Holden Planning Board

RE: Jefferson Mill Redevelopment – DPW Comments

**JEFFERSON MILL REDEVELOPMENT
1665 MAIN STREET, HOLDEN, MA**

Subcatchment 1S: Offsite Townhomes

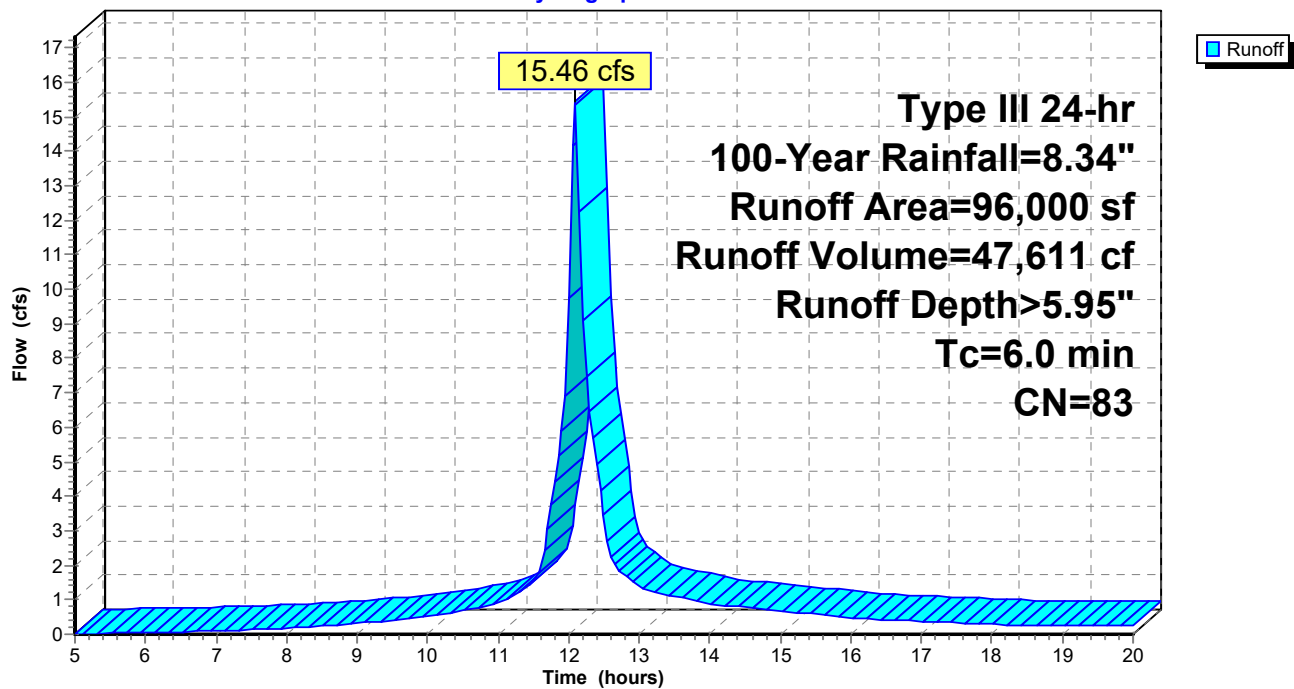
C3. Provide calculation of low and tech spec for the WQU for sizing

The sizing calc was provided directly from Contech and their proprietary software. Attached is the hydrologic calculation for determination of 100-Year flow from townhouse area and the 1-Inch runoff from contributing pavement surfaces that was provided to Contech.
